Index 700-102 Special Sign Details

COMMENTARY

**FY 2022-23
STANDARD PLANS**

SPECIAL SIGN DETAILS

INDEX	SHEET
700-102	10 of 12

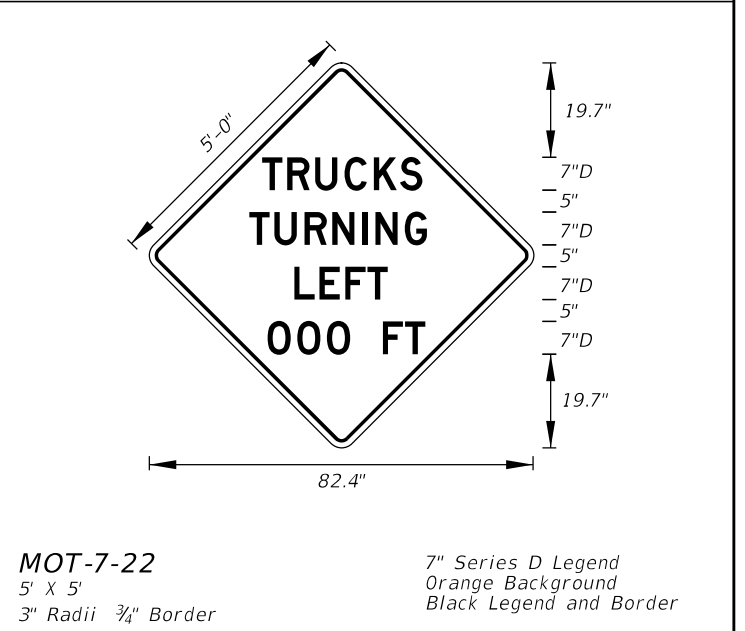
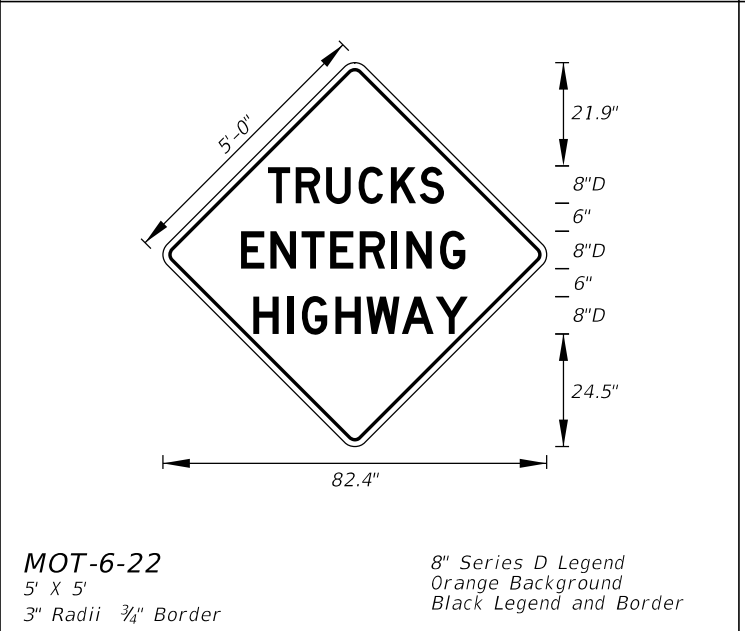
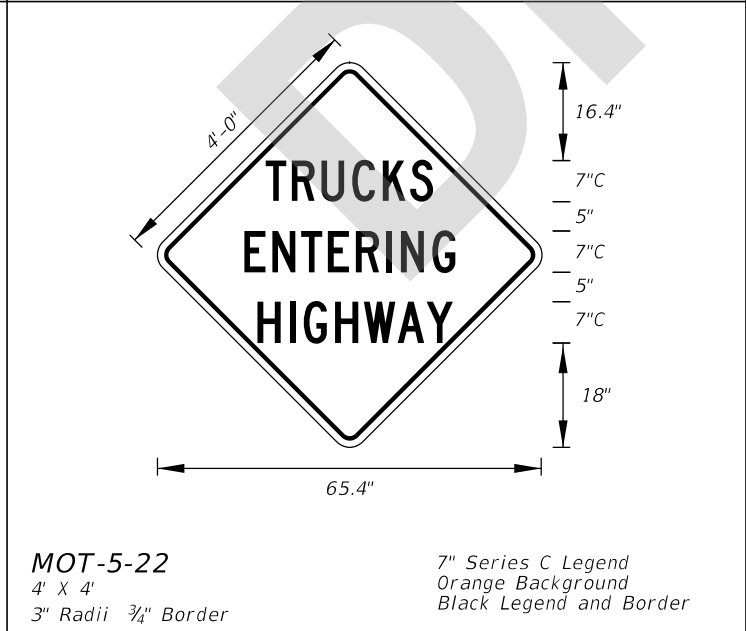
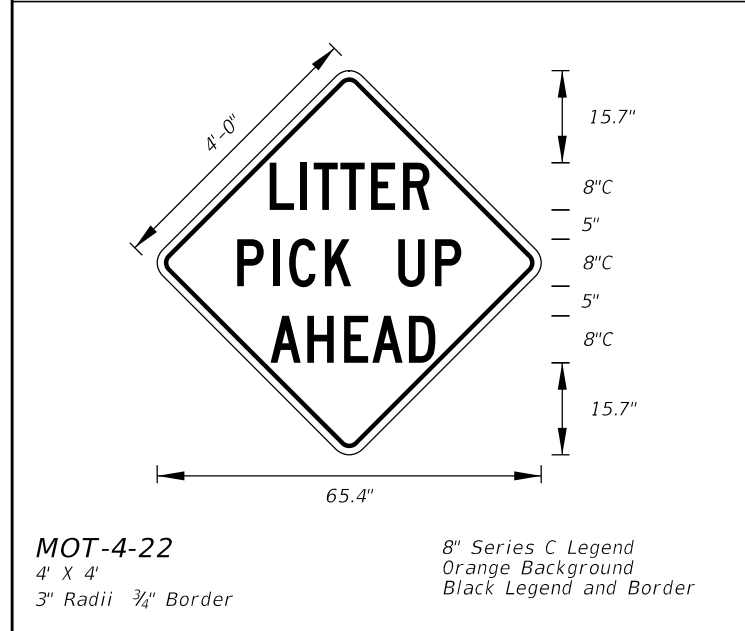
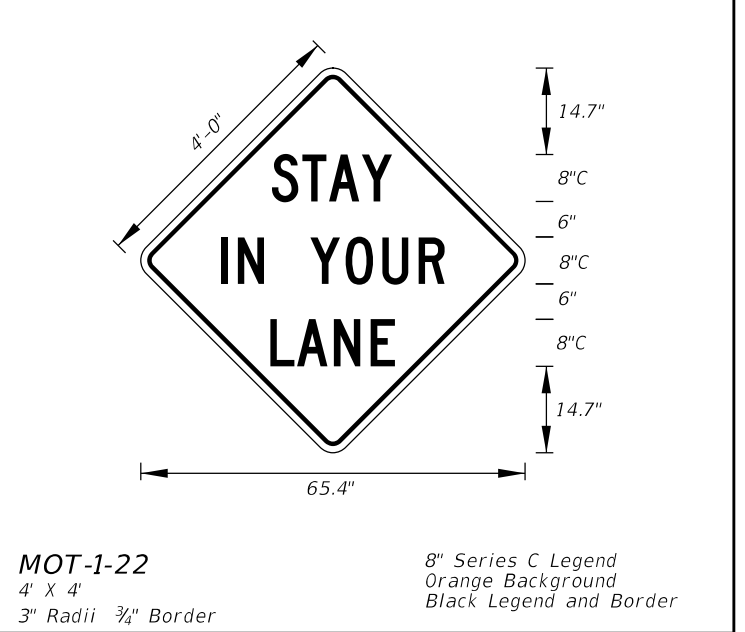
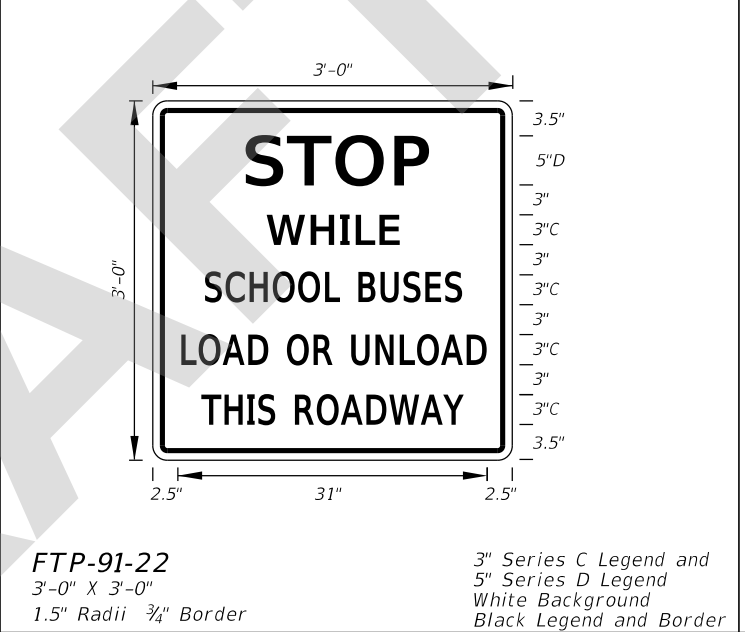
COMMENT: Proposed signs FTP-90-22 and FTP-91-22 should both say “STOP *while* school buses load or unload” instead of “STOP *white* school buses load or unload”. FTP-91-22 – recommend removing the “THIS ROADWAY” language as it doesn’t seem appropriate or needed.

RESPONSE: The typo on FTP-90-22 and FTP-91-22 signs will be fixed. For the comment on the ‘THIS ROADWAY’ sign: No changes needed, the ‘THIS ROADWAY’ text should remain on the sign. Guidance will be included in the next update to the Speed Zoning Manual for the ‘THIS ROADWAY’ sign. This new text will clarify that motorists must stop on a particular roadway since a bus stop is present on that roadway.

Change made to Index: Update FTP-90-22 and FTP-91-22 to correct typo.
